APPLICATION NUMBER: RECON 25/0220

PROPOSAL: 26 AFFORDABLE DWELLINGS, NEW ACCESS WORKS, LANDSCAPE PLANTING, A NEW PUMPING STATION AND ASSOCIATED WORKS

SITE: Land at Traston Lane Newport

FURTHER REVISION OR CLARIFICATION REQUIRED

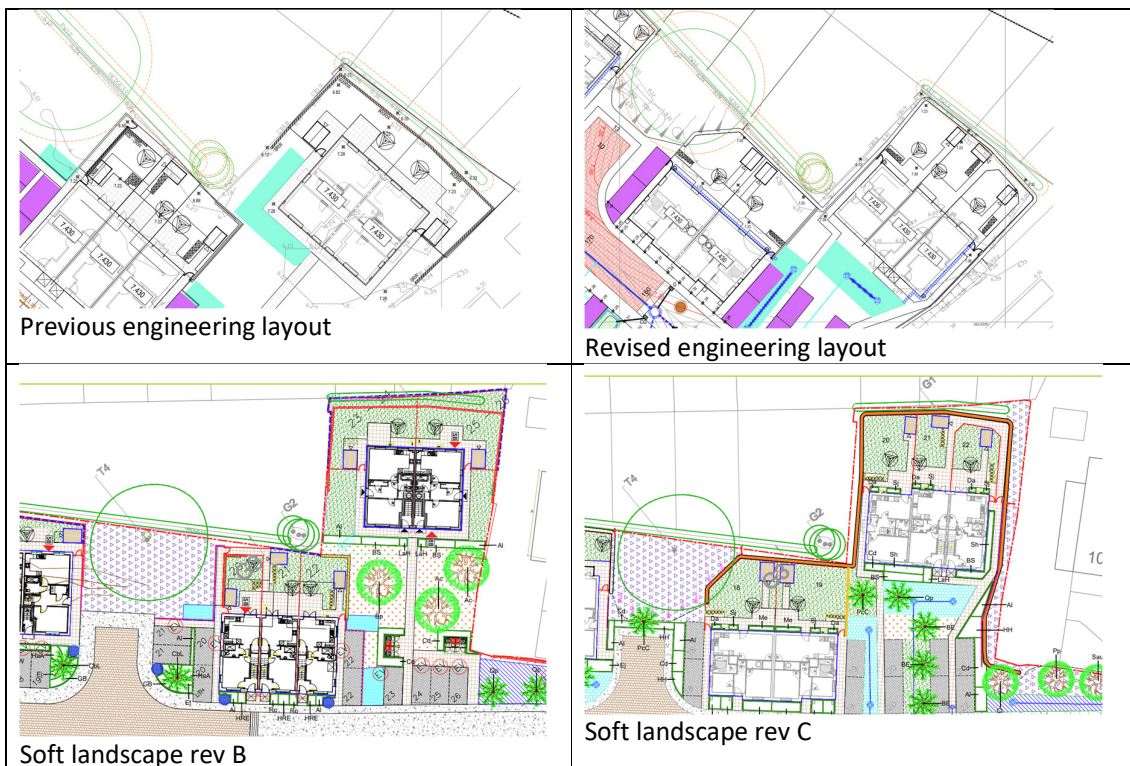
3. The hydroseeded wall also encroaches into the root protection area for T4 oak from both sides as highlighted below – I advise the arb consultant reviews the impact, offsetting maybe an option but the revised layout is not reviewed in the submitted AIA.
